Addendum #	2	Date Issued	10-25-2024
Project Name Job #	DSU Woods Hall Improvements - Phase 2		20233600
Bid Date Time	November 20, 2024		2 pm MDT

THIS ADDENDUM AMENDS AND BECOMES PART OF THE CONTRACT DOCUMENTS FOR EAPC PROJECT 20233600 DATED 1-16-2024. EACH BIDDER SHALL ACKNOWLEDGE RECEIPT OF THIS ADDENDUM BY MARKING THE ADDENDUM NUMBER AND DATE ON THE BID FORM.

DRAWING TITLE
SECOND FLOOR DOMESTIC PIPING PLAN

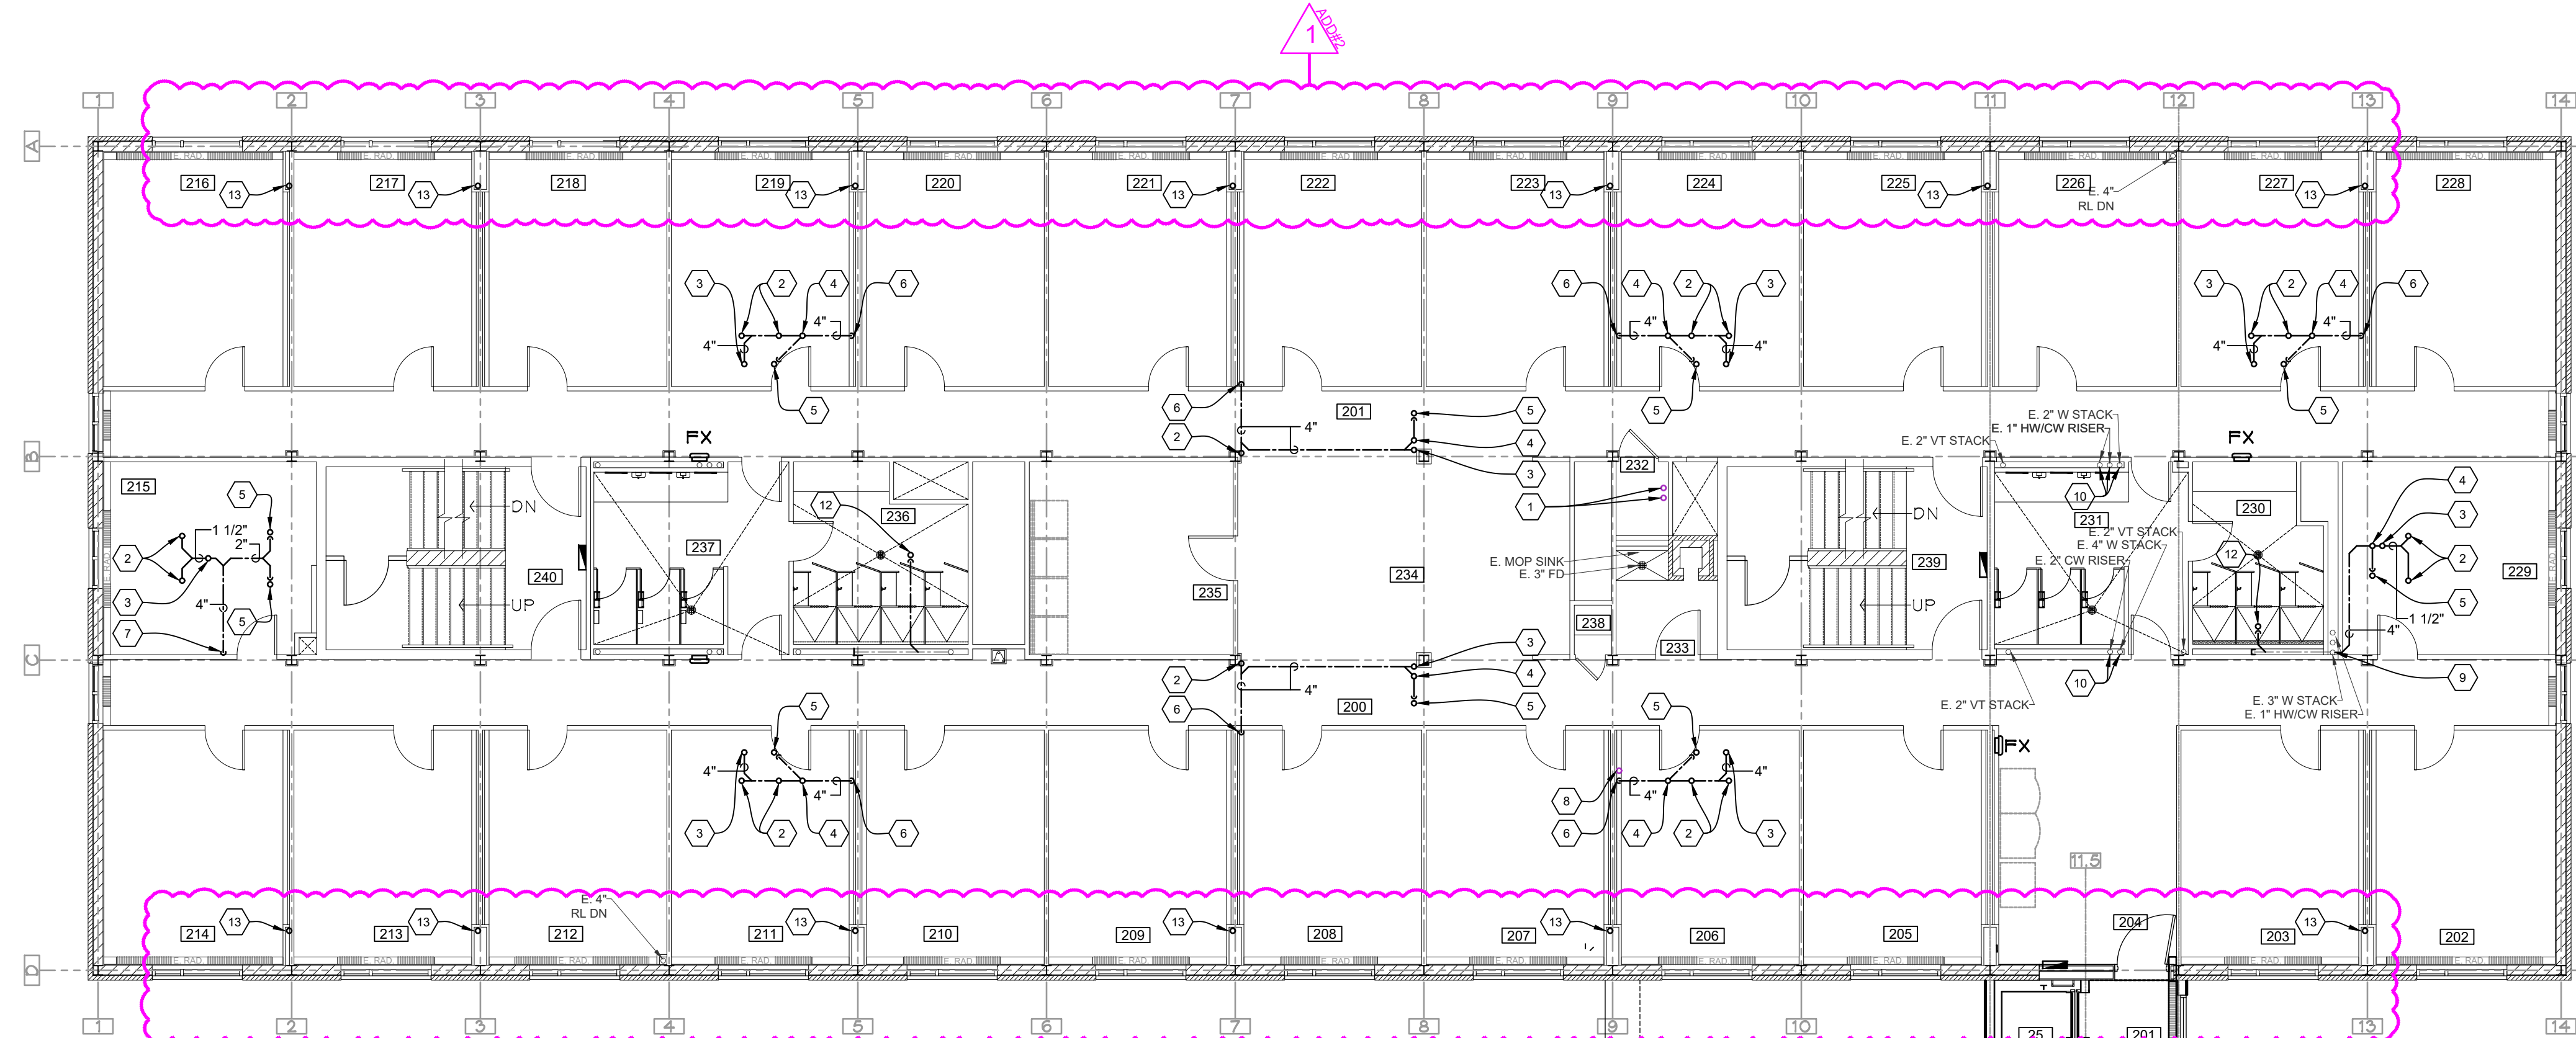
- a. Added new waste piping to serve the mini-split A/C units on third floor.
- b. Updated and added keynotes.

M2.3

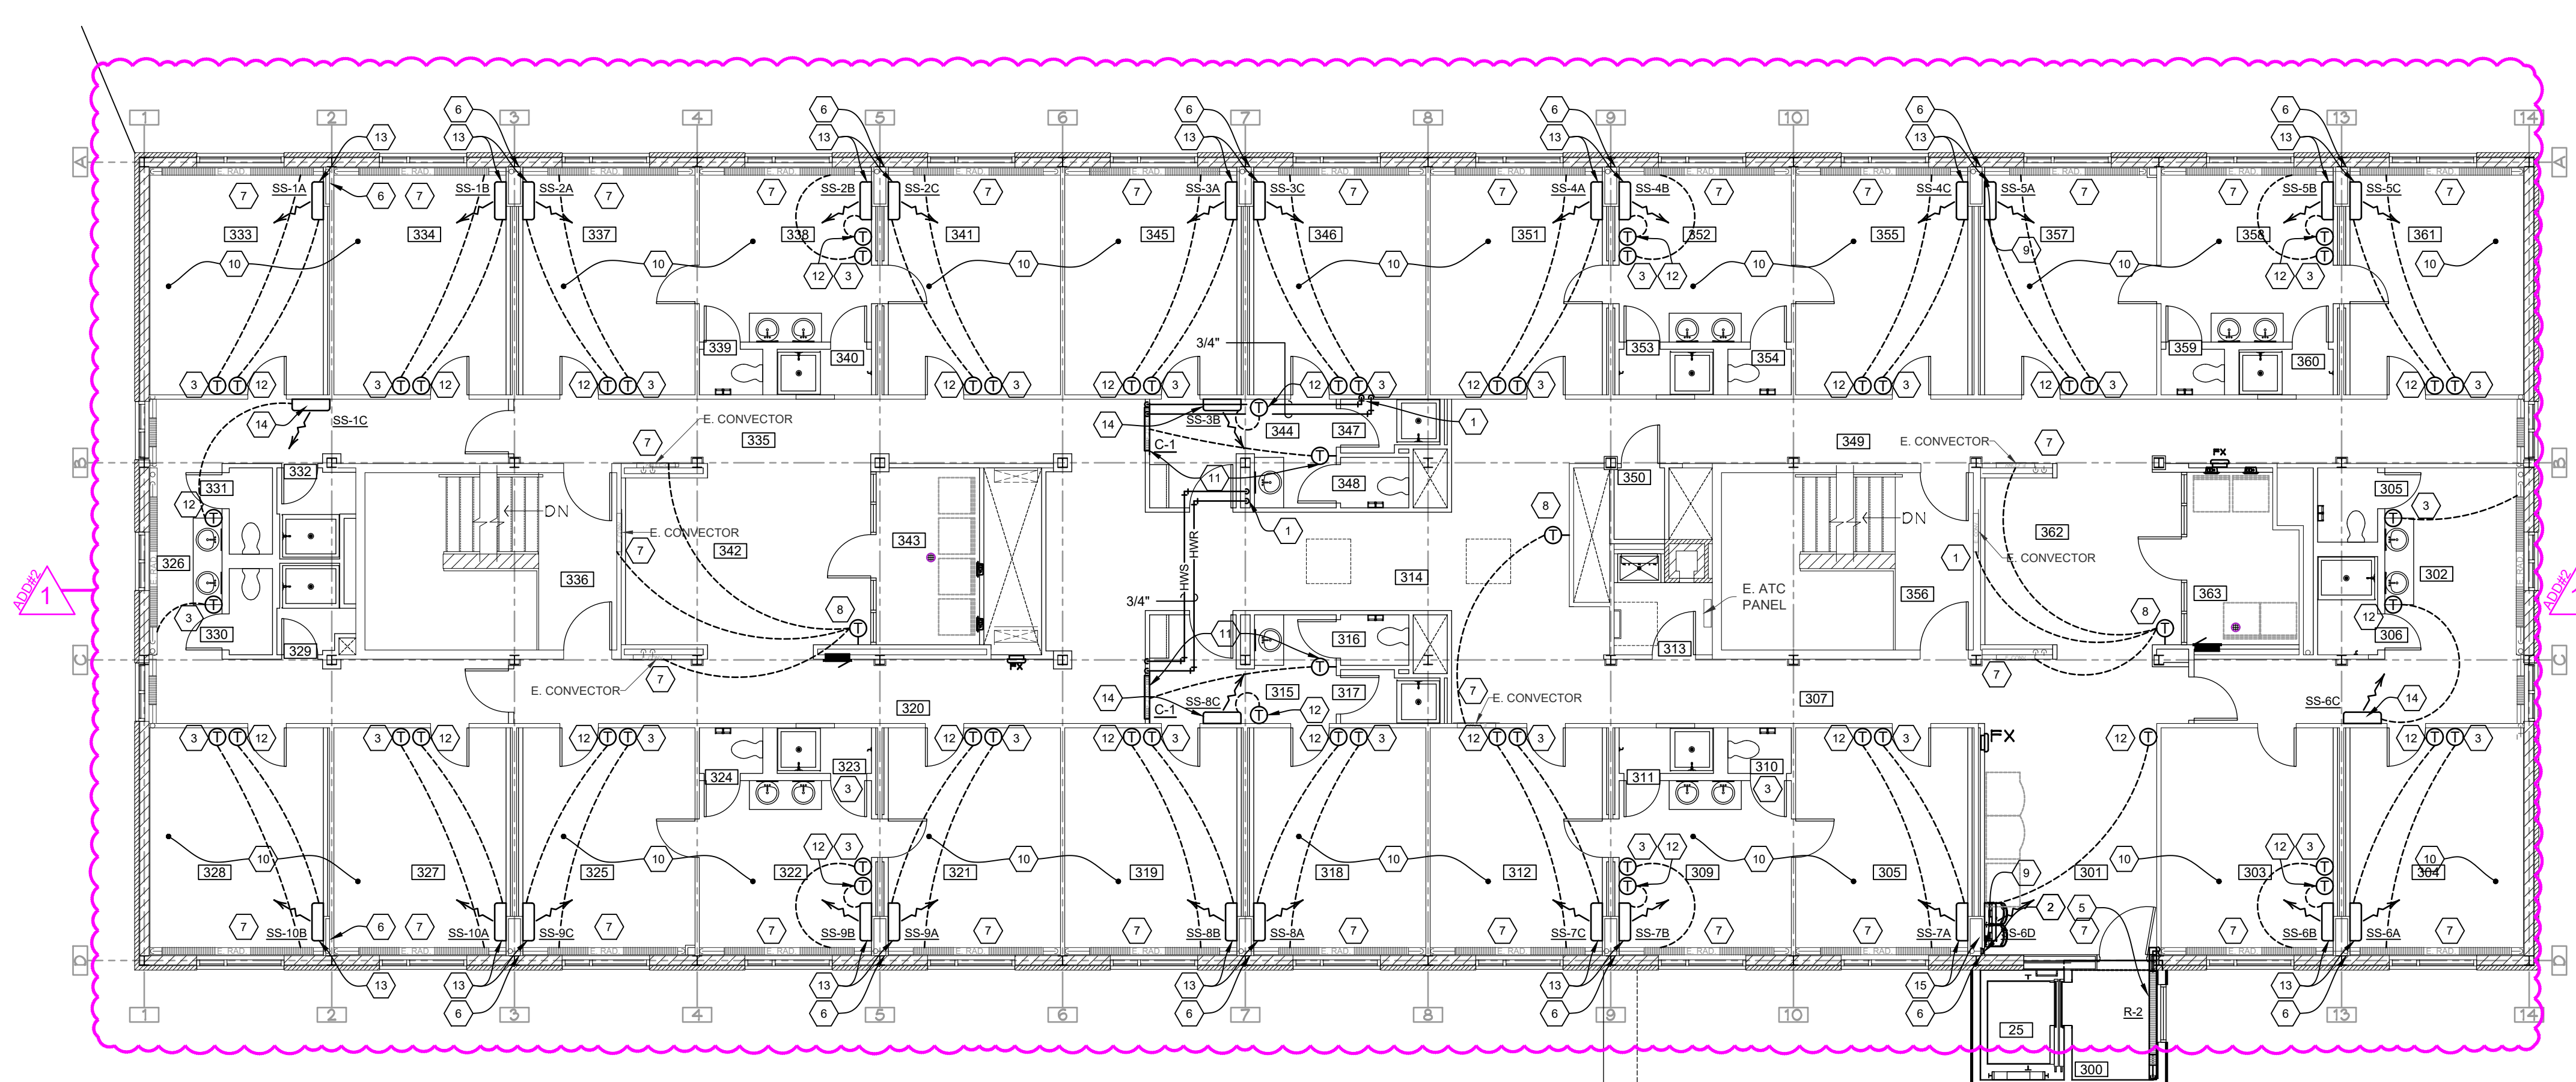
- a. Added Multi-Mini Split System Head units to the dorm rooms.
- b. Added thermostats for the mini-split systems.
- c. Added verbiage for condensate connections to the mini-split systems.
- d. Updated and added keynotes.

M3.3

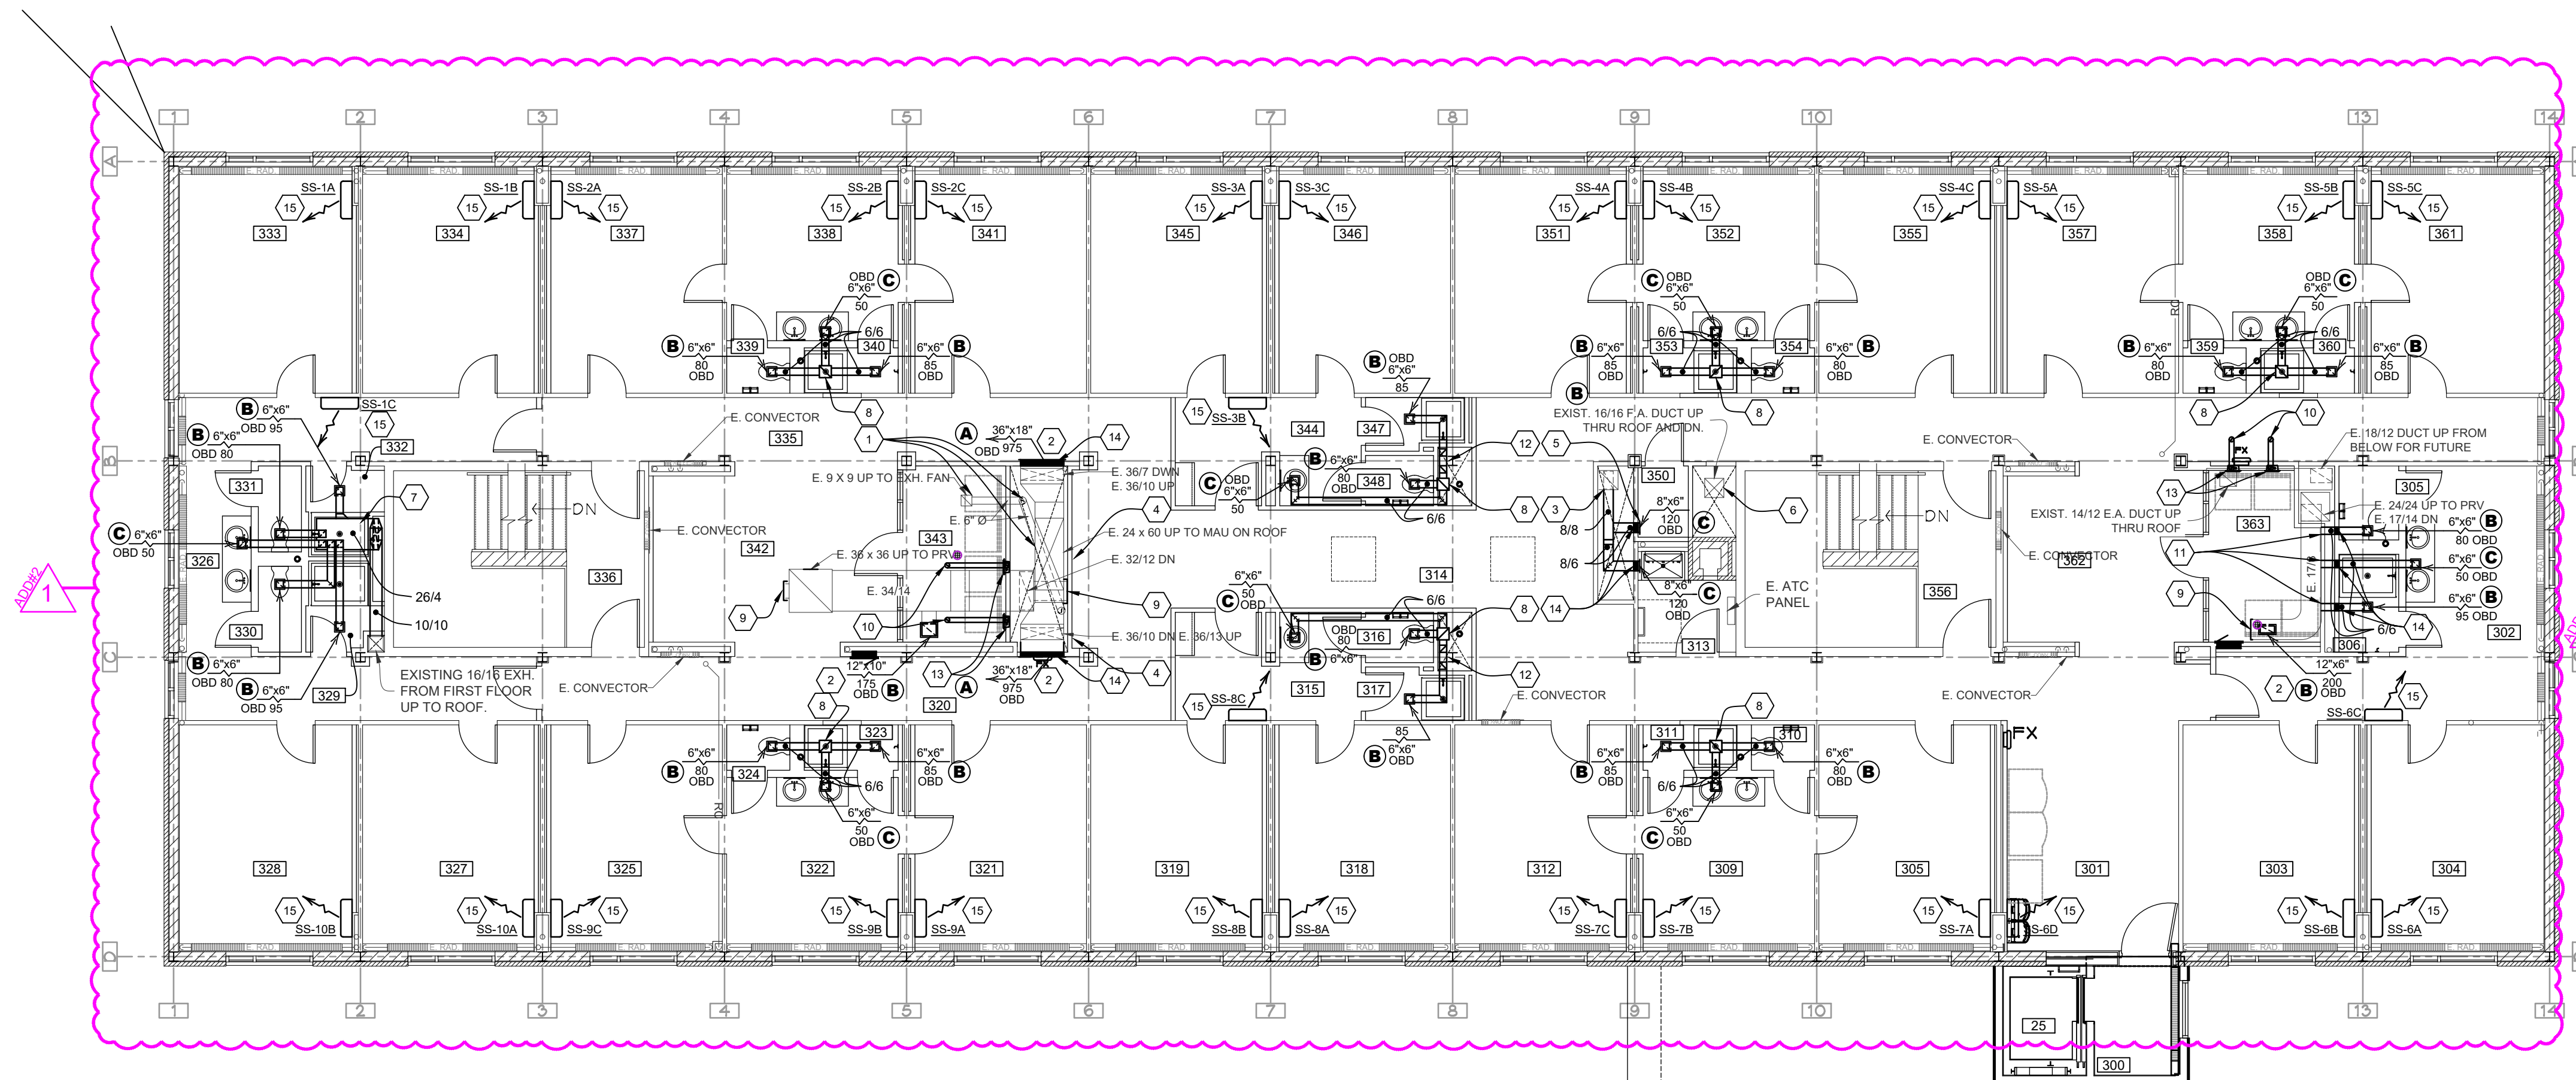
- a. Added Multi-Mini Split System Heat units to the dorm rooms.
- b. Updated and added keynotes.
